TRANSPORT ASSESSMENT

PROPOSED McDONALD'S RESTAURANT
LAND AT COMMON ROAD, PENYGARNDDU BUSINESS PARK
MERTHYR TYDFIL, CF48 2TA

Reference: ADL/CC/6197/16B

Document: Transport Assessment

Figure 4A Proposed Car Park Dimensions

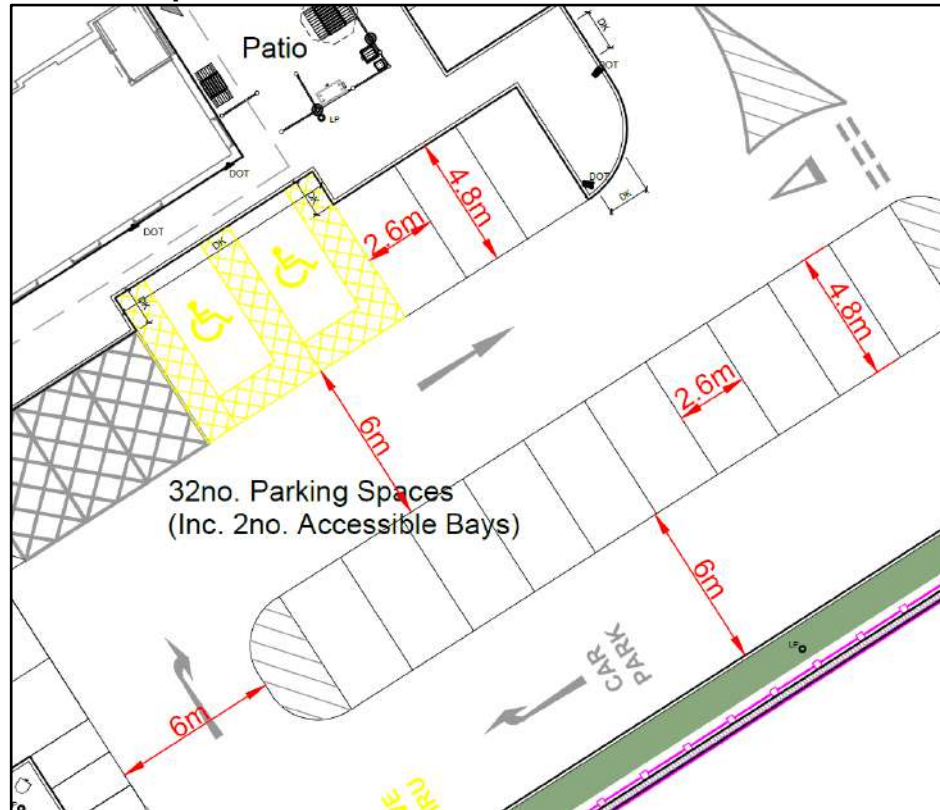
1.2.7 MTCBC advised that parking should be provided in line with the Wales Parking Standards (2014). The comments also state that parking bays should be 2.6m x 4.8m with a minimum 6m aisle width.

- The parking bays have been adjusted to 2.6 x 4.8m and the 1.2m pedestrian walkways removed to provide a minimum 6m aisle width.

4.4.8 The proposed parking spaces would be to 2.6 x 4.8m with 6.0m aisle widths. A plan showing the car park dimensions is included as Figure 4A below.

Figure 6A McDonald's Darlington Layout

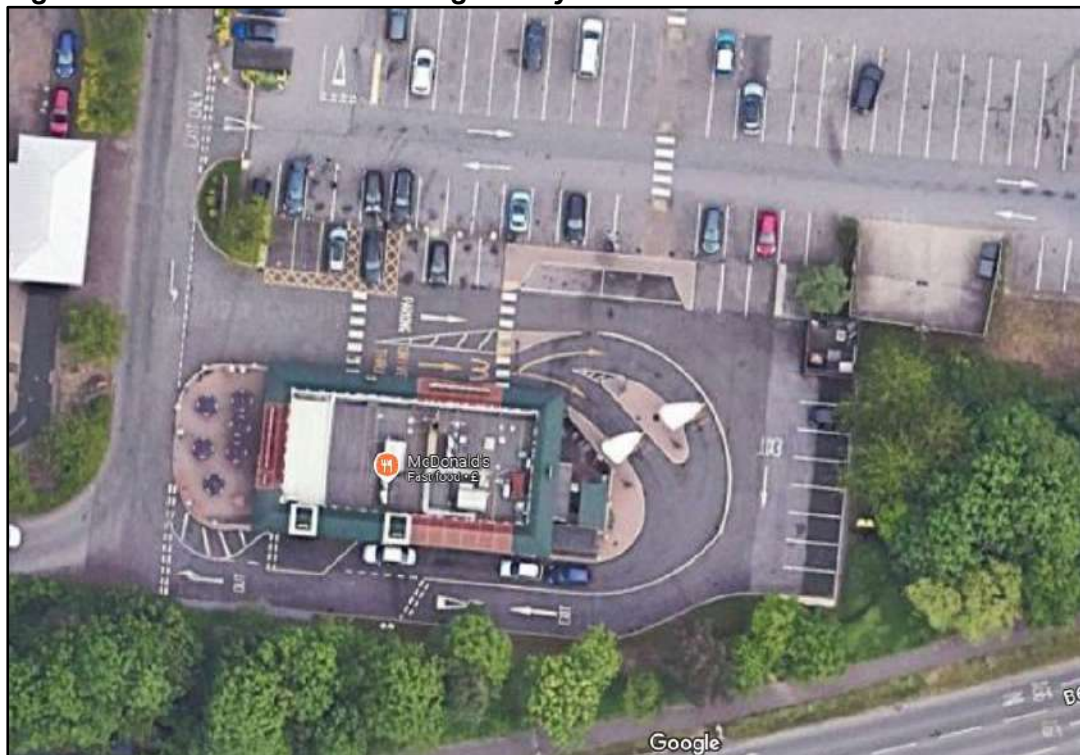
1.2.9 MTCBC noted that the raw data of the McDonald's survey data at the Darlington Restaurant appears to show that the number of cars parked was more than the number of parking bays. It is also noted that if the peak parking numbers for each of the sites is used then the average parking demand for the sites used is 26 during the Friday Peak and 30 during the Saturday peak. MTCBC advised that if 5 vehicles are added to allow for fluctuation, the site would need between 35 and 40 spaces.

- In response: It is considered that the anticipated peak parking demand of 25 vehicles is correct. Further information is provided in Chapter 6.0 of this report.

6.2.4 As stated in the pre-application comments provided by MTCBC, the parking demand at the Darlington Restaurant appeared to show that the parking demand was higher than the number of parking bays. As shown below in Figure 6A, at the Darlington restaurant the layout means that customers perceive the adjacent aisle of parking to the restaurant as part of the site therefore to ensure that all customer traffic and parking demand for the McDonald's was recorded correctly these spaces were included in the survey.

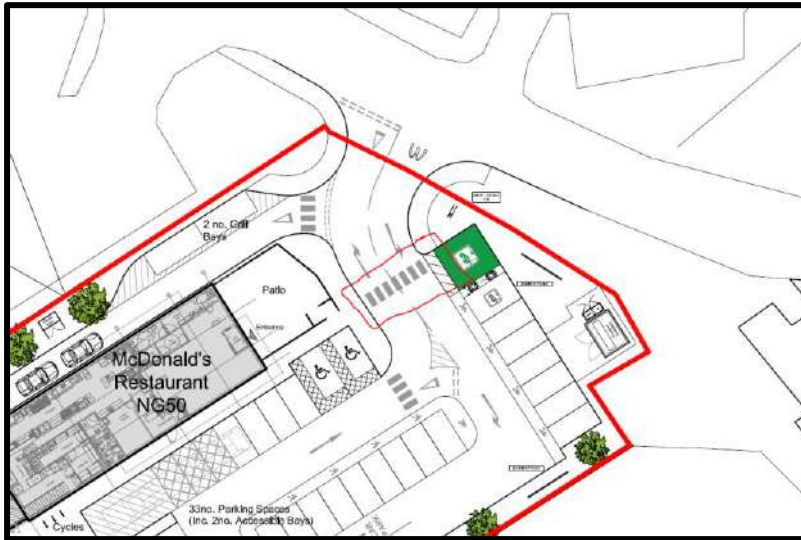
Within the submitted documentation, **Pre Application Traffic Note** the raw data provided shows that the maximum drive through demand is a total of 19 vehicles based on the submitted survey, whilst the average of the sites is 15 on a Saturday not 13 vehicles as stated within the body of the document. The methodology of taking the raw data and using the average for a whole day is flawed as only maximum queue lengths should be averaged. The proposed 17 spaces for a queue should be reviewed as it will not be acceptable for cars entering to queue to block through movement for other vehicles.

- In response: The average of the three sites is considered appropriate. Further information is provided in Section 6.3 of this report. Even in the event that the maximum drive thru demand was 19 vehicles there would still be sufficient capacity in the drive thru lane.
